UNITED STATES PATENT AND TRADEMARK OFFICE

APPLICATION NO.	FILING DATE	FIRST NAMED INVENTOR	ATTORNEY DOCKET NO.	CONFIRMATION NO.
10/790,217	03/02/2004	Akira Yoneoka	P21-163407M/NY	9855
21254	7590	06/21/2006	EXAMINER	
MCGINN INTELLECTUAL PROPERTY LAW GROUP, PLLC 8321 OLD COURTHOUSE ROAD SUITE 200 VIENNA, VA 22182-3817			MITCHELL, KATHERINE W	
			ART UNIT	PAPER NUMBER
			3677

Office Action Summary

DETAILED ACTION***Continued Examination Under 37 CFR 1.114***

Below are the only original disclosures of projection on {an edge of} said slits:

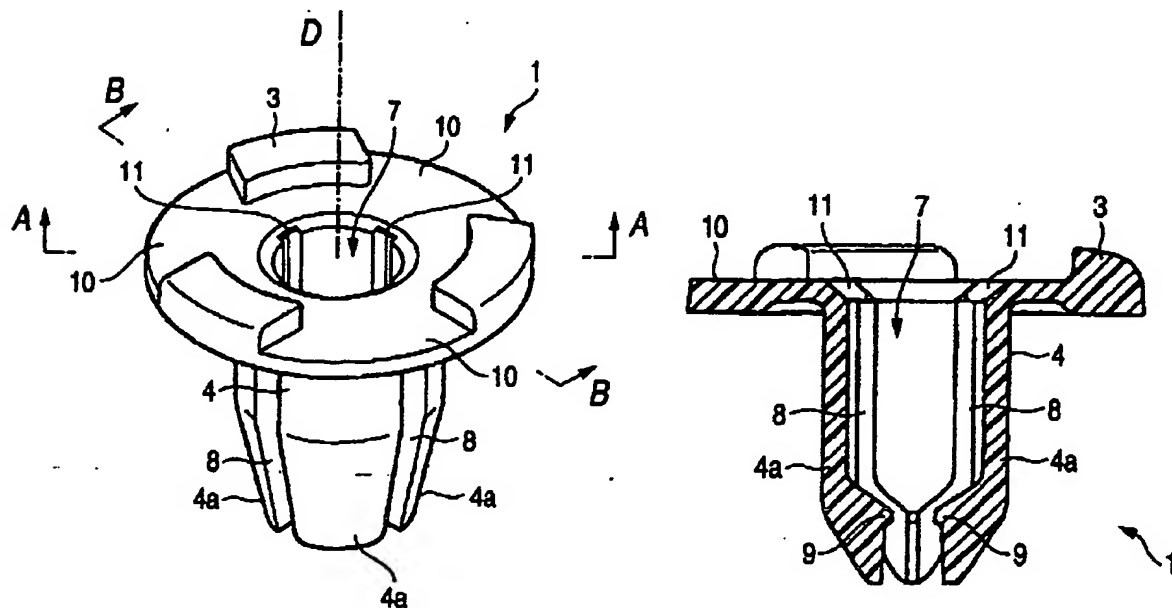
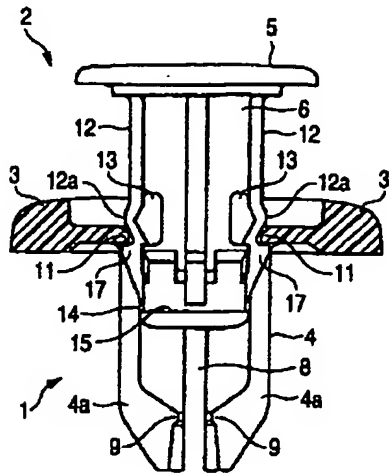
- o The figures show rib walls 12 on pins, so the projection is assumed to be on the grommet. Spec discloses projections 11, shown as recess, not projection. Is applicant considering a recess to be a –hole projection–, which is contradictory to the accepted meaning of projection. Where applicant acts as his or her own lexicographer to specifically define a term of a claim contrary to its ordinary meaning, the written description must clearly redefine the claim term and set forth the uncommon definition so as to put one reasonably skilled in the art on notice that the applicant intended to so redefine that claim term. *Process Control Corp. v. HydReclaim Corp.*, 190 F.3d 1350, 1357, 52 USPQ2d 1029, 1033 (Fed. Cir. 1999). The term is indefinite because the specification does not clearly redefine the term.

How projection "11" correlates in Figs 1, 2A and 4 above, with the specification and claim 17 is unclear. Applicant should explicitly clarify.

FIG. 5

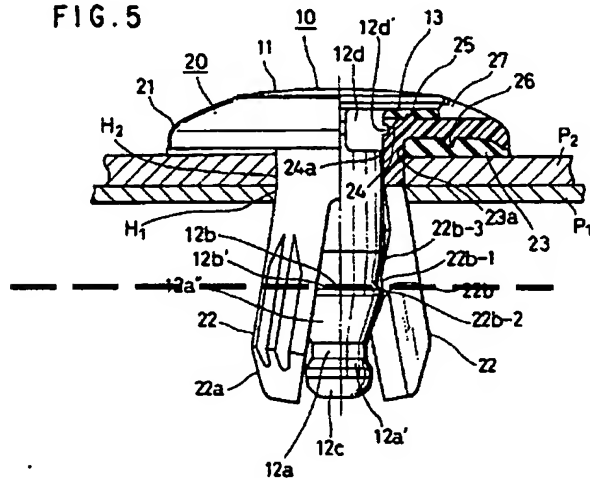
Re claim 1: Ueno OR Anderson OR Plimi Jr teach a jointing member comprising a grommet and pin. The grommet has a flange and leg portions, capable of being opened, and there is an insertion hole in the center of the flange to an inner portion of the leg. There is an engagement portion on the leg portion. The pin includes a head and shaft, said shaft insertable in the insertion hole of the grommet, the shaft has an

The distance from the grommet flange to the grommet leg portion tip is greater than a

FIG. 1

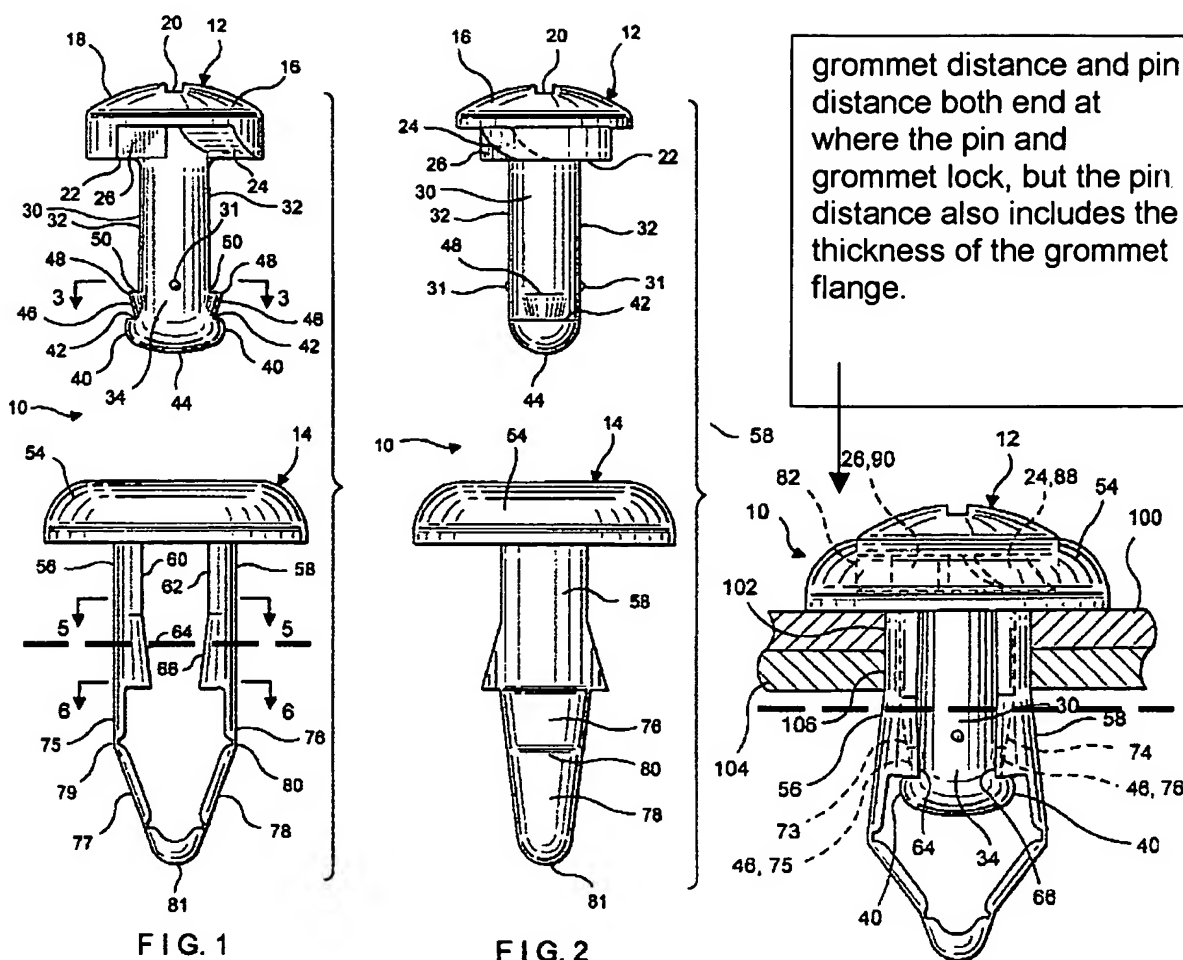
Re claim 1: LeVey teaches jointing member comprising a grommet 14 and pin 12. The grommet has a flange and leg portions, capable of being opened, and there is an insertion hole in the center of the flange to an inner portion of the leg. A lower end of the leg portion is opened, (between 77 and 78 is opened, and this is at a lower end) although it is not a through opening through the axial tip. There is an engagement portion (75,76, Fig 9 and 10, col 4 lines 34-53) on the leg portion. The pin includes a head and shaft, said shaft insertable in the insertion hole of the grommet, the shaft has an engagement surface (40 to 46 below) and a lock surface (at 48,50) each engageable with the engagement portion. The distance from the grommet flange to the grommet leg portion tip is greater than a distance from the pin head to the pin tip.

Re claim 13: There are a plurality of slits (best seen Fig 1 – between leg portions 77,78, in the grommet dividing the leg into a plurality of leg pieces.

Re claim 14: Anything below the dashed line by examiner is considered where an expanded tip end side of the leg begins. Note that Fig 9 shows how this section expands when inserted. The engagement portion is formed on the inner surface of this tip end side.

Re claim 21: The distance from the grommet flange to the grommet engagement portion is smaller than the distance from the pinhead to the pin lock surface (best seen in Fig 9)
